Oaklands Farm Solar Park application for non-material change 2025 (SI 2025/739
EN010122

Please find attached appendix 2 re map

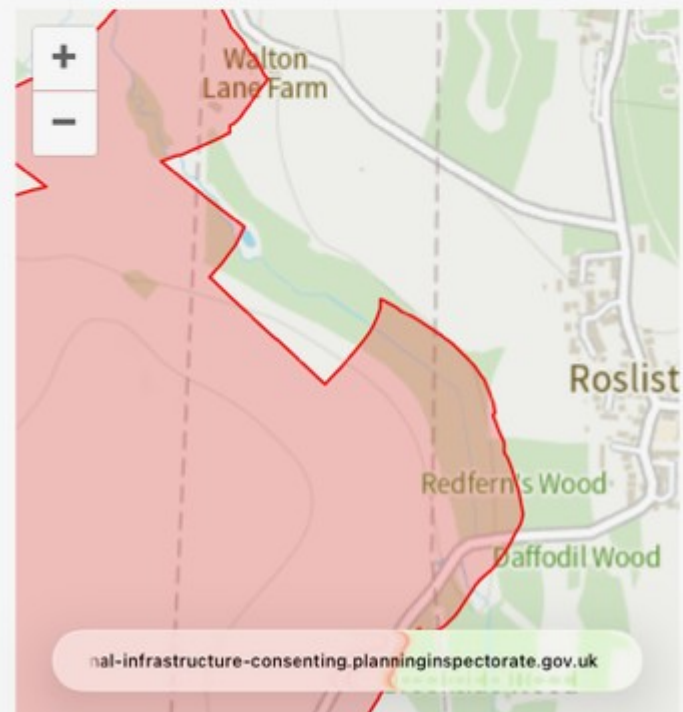
The maps I have read online are of particular concern and I hope are I hope not to scale as they appear to have encroached onto my 93 year old Father's land (Appendix 2)

I am confident this map is not to scale but I would like to be clear regarding boundaries as mature woodland is immediate neighbour to this site and need to ensure buffer of 5m is correct before fencing goes up as fire precaution and access would be required for hedge cutting. The maps show solar panels up to this boarder on the maps I have seen ???
